**City of Bellevue  
Development Services Department  
Land Use Division Staff Report**

Proposal Name: Bellevue Office Tower

File Number: **13-119862 LD**

Decisions Included: Design Review with SEPA, Process II

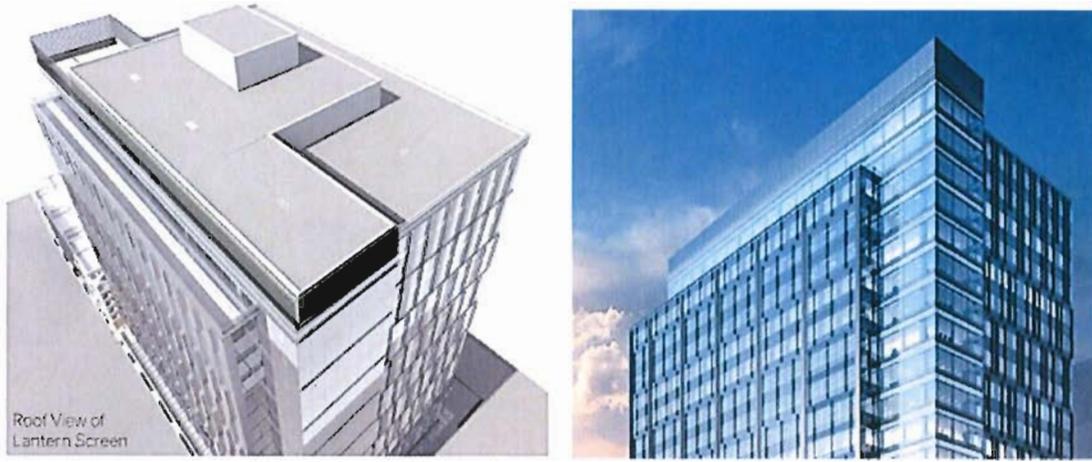
The applicant should note that changes to the shown roof details below are subject to approval by staff and consistency with the code during building permit review. Modification to the roof design/mechanical equipment without approval may place the additional height at risk for reduction to elevation 431.74 feet. See Section X for related condition.

Height modifications are granted because the applicant has proposed the following:

- The placement of the elevator overrun is in the center of the building,
- A 17 foot architectural aluminum louver wall screens both roof top cooling towers and mechanical penthouse structure,
- Rooftop screen walls are located to complement building massing and provide continuity to and accentuate the building 'lantern massing',
- Additional building height provides a proportionally slimmer building massing and variation in the roof plane,
- Illuminated building lantern provides a dynamic addition to the Bellevue skyline and a unique architectural feature defining the building identity,
- The colors and materials used for the mechanical equipment and penthouse screen wall will match the building body creating an architecturally integrated system.

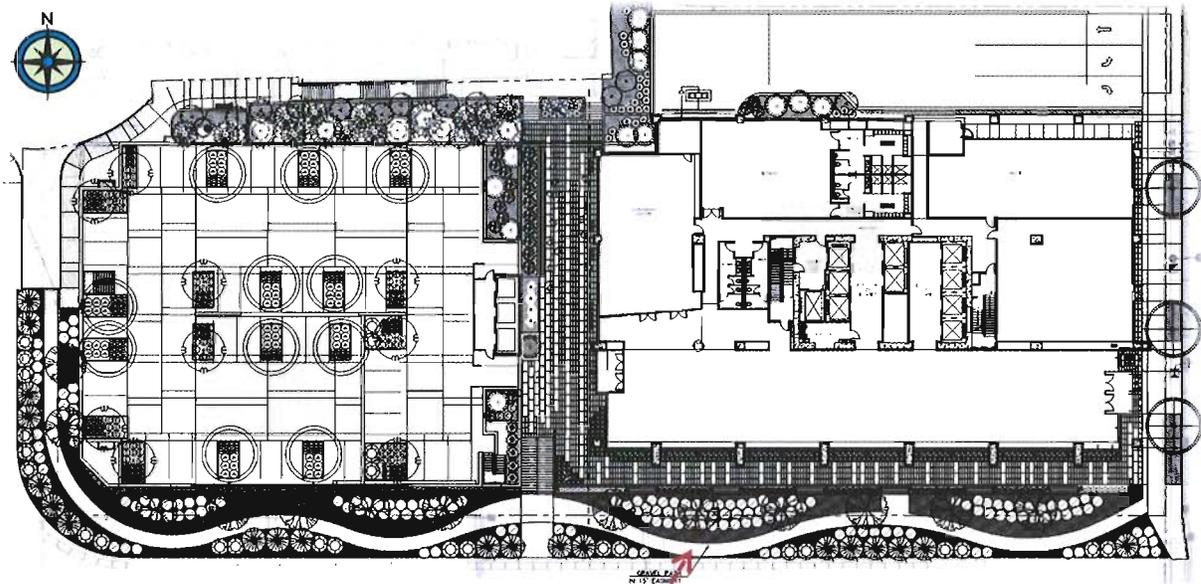
## **VII. CHANGES TO PROPOSAL DUE TO CITY REVIEW**

- Calculation of the average finished grade was requested as the applicant had completed the calculation based upon average existing grade. Re-calculating the grade required the applicant to qualify for additional height due to the increased height of the elevator overrun in the center of the roof. See Section IV.B for further discussion and height modification approval.
- Parking dimensions with the parking garage did not conform to LUC 20.20.590, Table 3. The garage was re-dimensioned to fulfill this standard.
- Enhancement of the parking garage design to ensure compatibility with the adjacent residential tower, Washington Square.
